H-11165

DESCRIPTIVE REPORT

General Locality NORTHERN CLARENCE STRAIT

Sublocality Lincoln Rock to Point Stanhope

Figure 5: Survey Junction

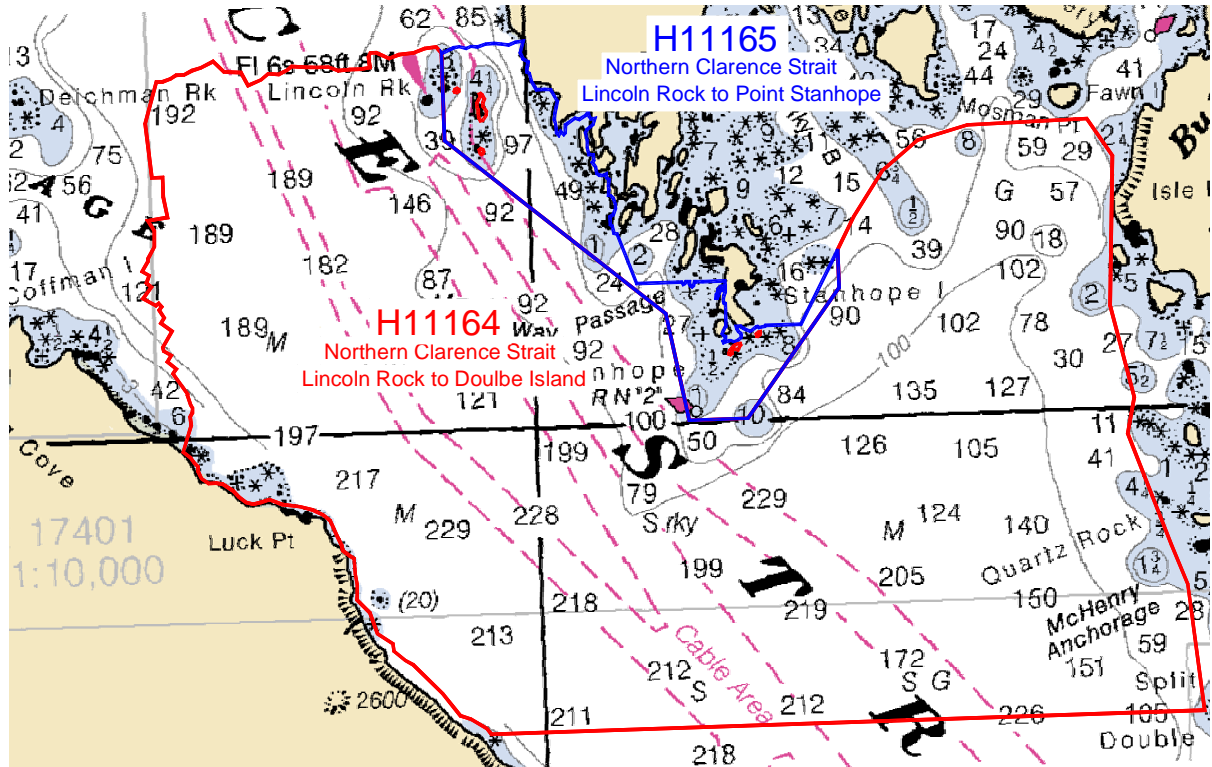
The surveys are in agreement along their common borders. The agreement was noted in the field using the DTM's created for coverage verification. The conformity is also apparent in their preliminary smooth sheets.¹²

¹² Concur. In PHB processing, H11165 was also compared at its northern junction with H10959. The comparison was generally excellent, within one fathom. However, in the junction areas along the eastern shore where the bathymetry is steep, H11165 generally found shoaler soundings than H10959, with differences up to 5 fathoms. Charted depth curves within the common areas have been drawn with consideration for all data sets within the common areas. Supersede depths from H10959 in the common areas except as specifically noted in this report and the Hdrawing.

Figure 6 Histogram for 8101 (Minotaur)

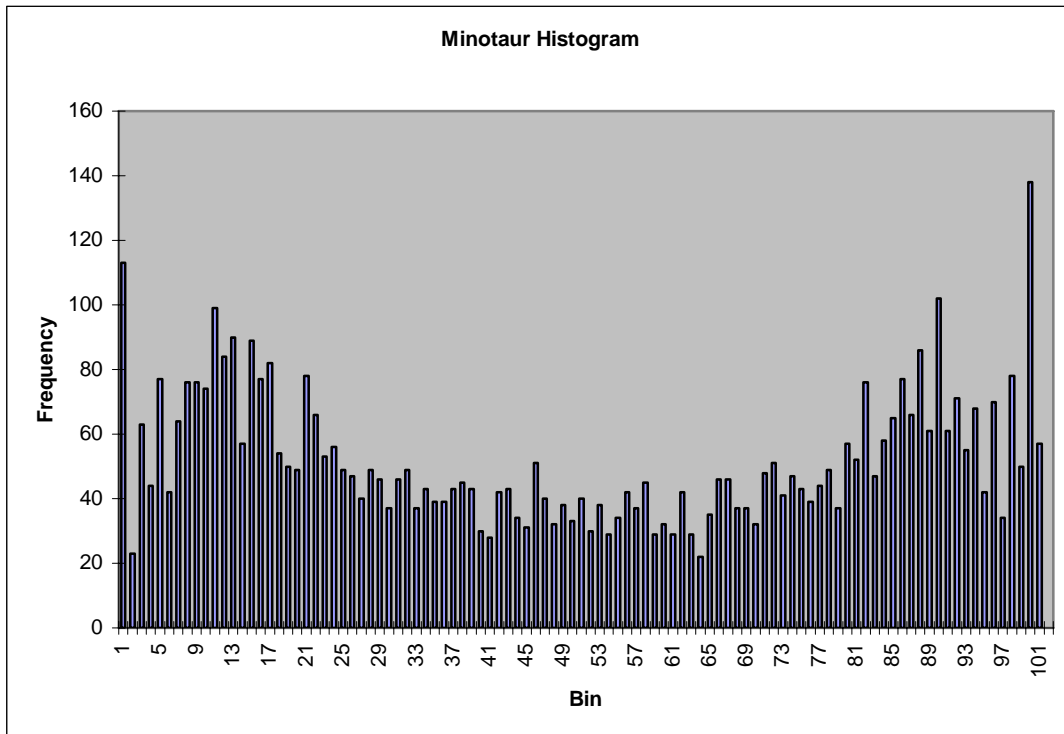
Figure 6 Histogram is for the Reson 8101 data collected from July 17, 2002 to September 17, 2002 on the Minotaur. The histogram shows an increase on selected soundings from the outer beams. This is the result of surveying near the shoreline and the simple fact that the outer beams are the shallowest. Also the majority of lines were run¹³, port beams overlapped with port beams and starboard beams overlapped with starboard beams from the adjacent lines. This makes it possible to have higher density data per square meter on the outer edges, leading to a higher chance of sounding selection on the smooth sheet.

¹⁴ Concur with clarification. The histogram shows a sharp drop in the selection of soundings from the outermost beams, approximately 1-5 and 95-101. Data from the outermost beams is often filtered out or rejected in processing due to poor quality. In the range of acceptable beams, the histogram shows the pattern as described.

Figure 7 Histogram for 8101 (QuickSilver)

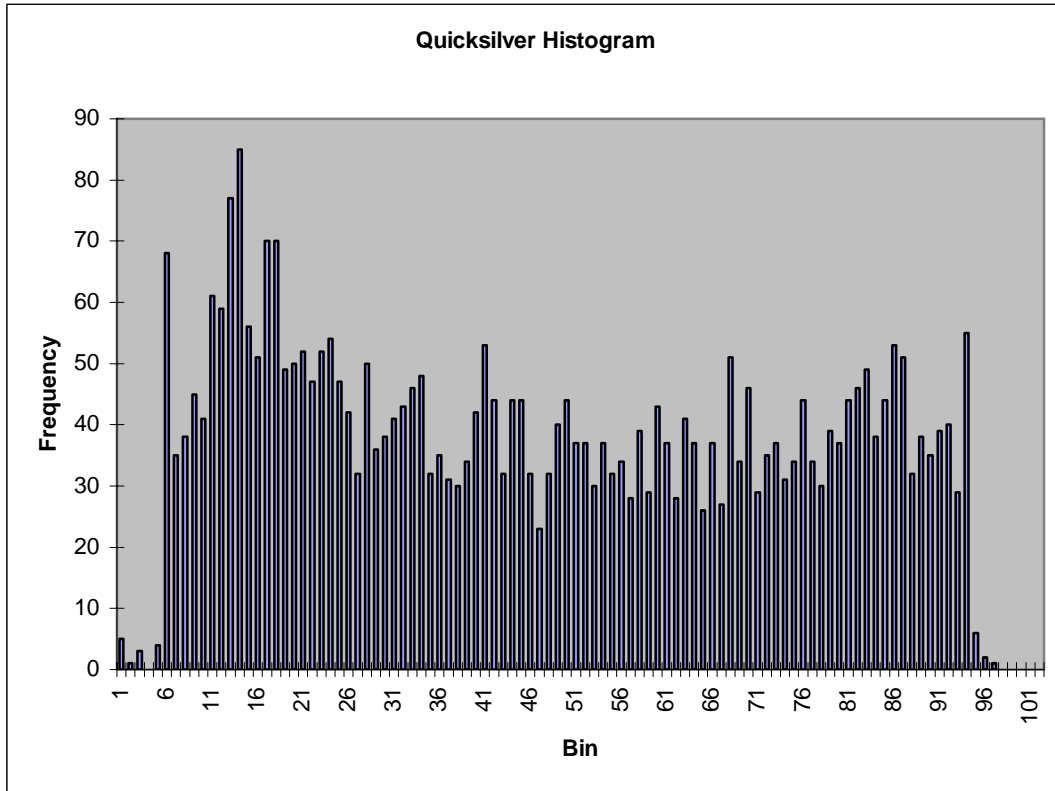
Figure 7 Histogram is for the Reson 8101 data collected from July 17, 2002 to August 11, 2002 on the Quicksilver. The histogram is evenly distributed, but there is an increase on selected soundings from the outer beams.¹⁴ This is the result of surveying near the shoreline and the simple fact that the outer beams are the shallowest. It is more noticeable on the port side because the captain was seated on the port side¹⁵ of the vessel and due to safety reasons they wanted to run the lines with the port side to the shore. Also apparent, is the transition from phase to amplitude detection of the sonar (beams 36 and 68) and any errors due to sound velocity.

¹⁵ Concur with clarification. The histogram shows an increase in sounding selection between approximately beams 6 through 27 on the port side.

Figure 9 DP Correlator Sheet

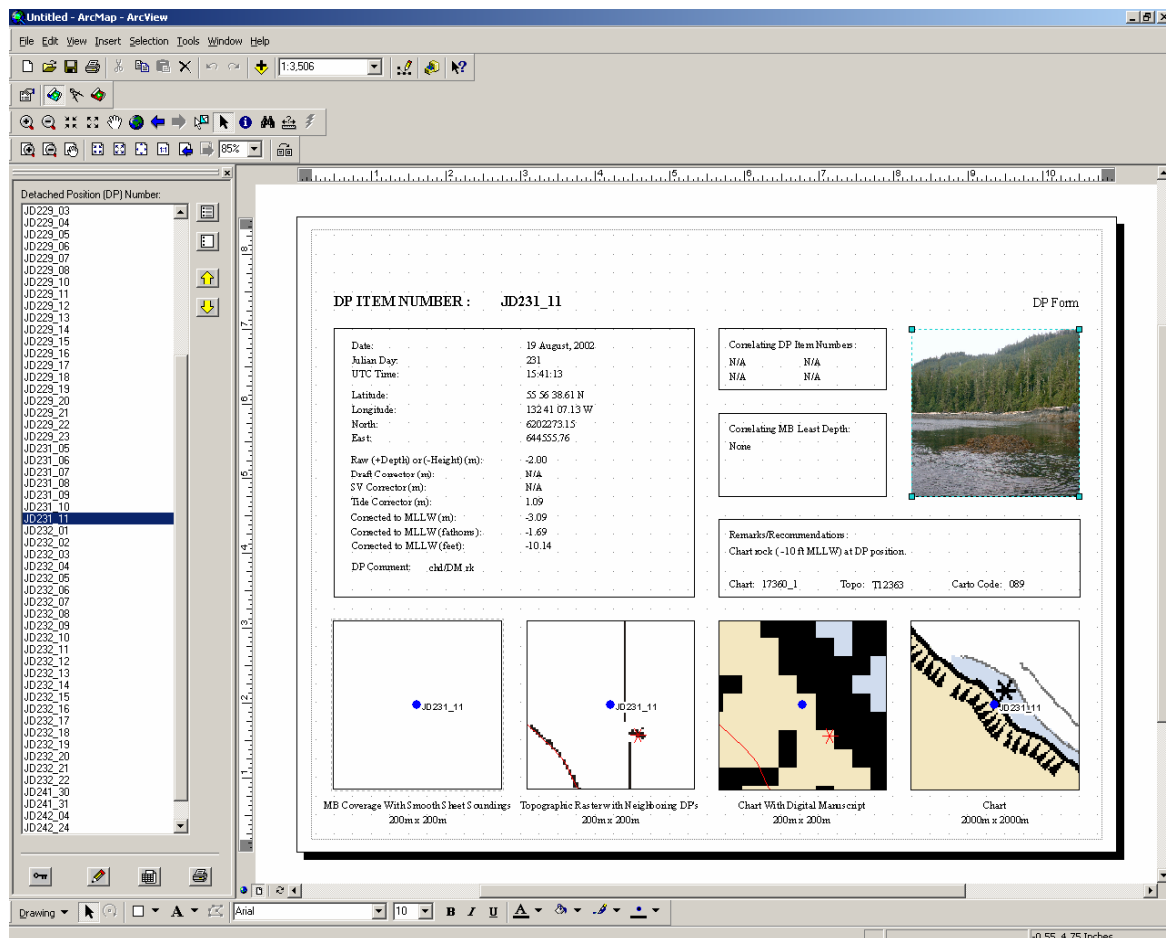
3. Charted rock at 56 1 31.18 N, 132 34 42.08 W is outside the survey limits and was not proved or disproved by multibeam coverage. A 10-minute visual search was performed and no indication of a rock, shoal, or kelp was seen. DP #JD242_003 was taken at the charted rock location and a 29.0 meter leadline depth was obtained. The hydrographer recommends that the charted rock be deleted.⁶⁸

- ⁶⁷ Concur with clarification. The rock is not charted on 17382, 16th Edition. Chart the area as depicted on the smooth sheet.
- ⁶⁸ Do not concur. The DP Correlator Sheet states that the leadline depth is inaccurate and should not be plotted. The evaluator recommends retaining the charted rock until a multibeam investigation of the area proves or disproves its existence and location.
